2 COMMENTS AND RESPONSES

RE: Comments on Corte Madera Creek Flood Risk
Management Project, Phase 1 Draft EIR

2.4.1 Response to Letter B1: Friends of Corte Madera Creek Watershed

Figure 3.15-1 Utilities and Service Systems in the Project Area (Map 1 of 3)

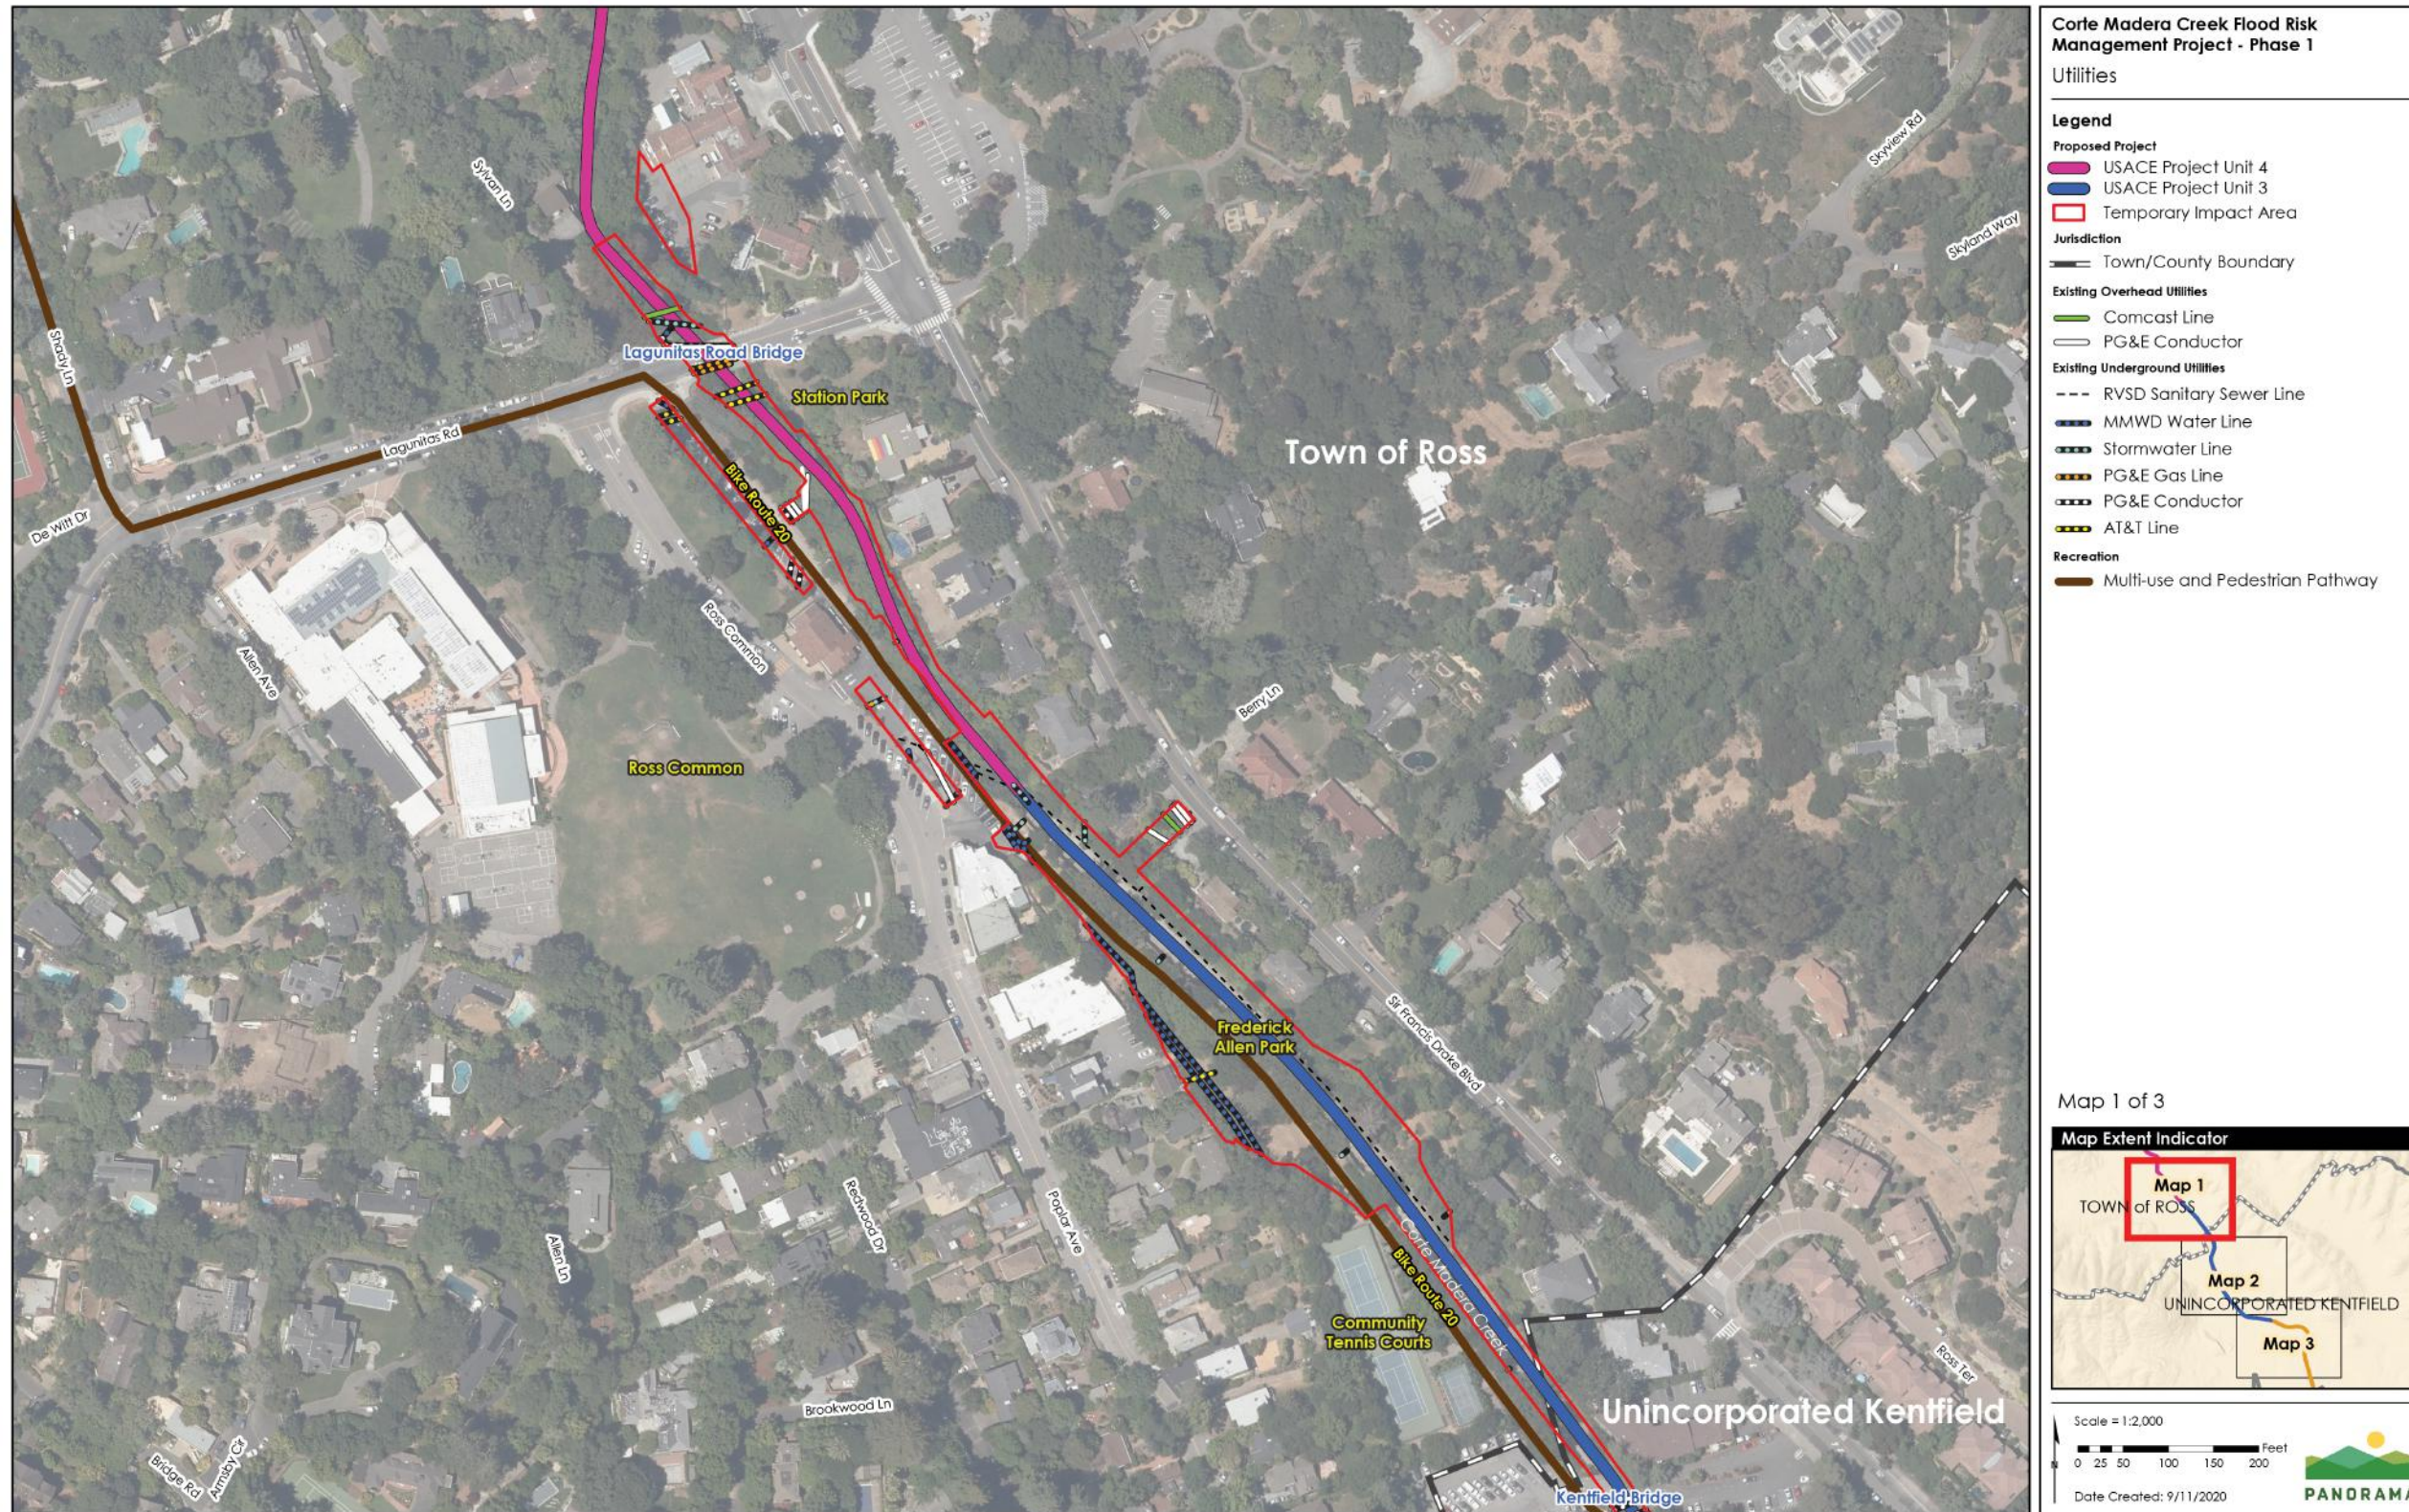
The legend refers to MMWD stormwater lines. This is inaccurate: MMWD supplies treated domestic water; towns and the District are responsible for stormwater. The Design Basis Report (GDG 2020) describes utilities in the Lower COM project area, most of which are not shown accurately on Figure 3.15-3. Also, the outline of the Lower COM project area is inaccurate. It shows two areas that should be removed from the figure: the inaccurate staging area and an area on the left bank that has since removed from the project. Please use the most recent 65% designs.

Figures 3.15-1, 3.15-2, and 3.15-3 in the Draft EIR have been revised as follows (on the next pages) to reflect the utilities and project components as shown in the Basis of Design Report for the Lower College of Marin area.
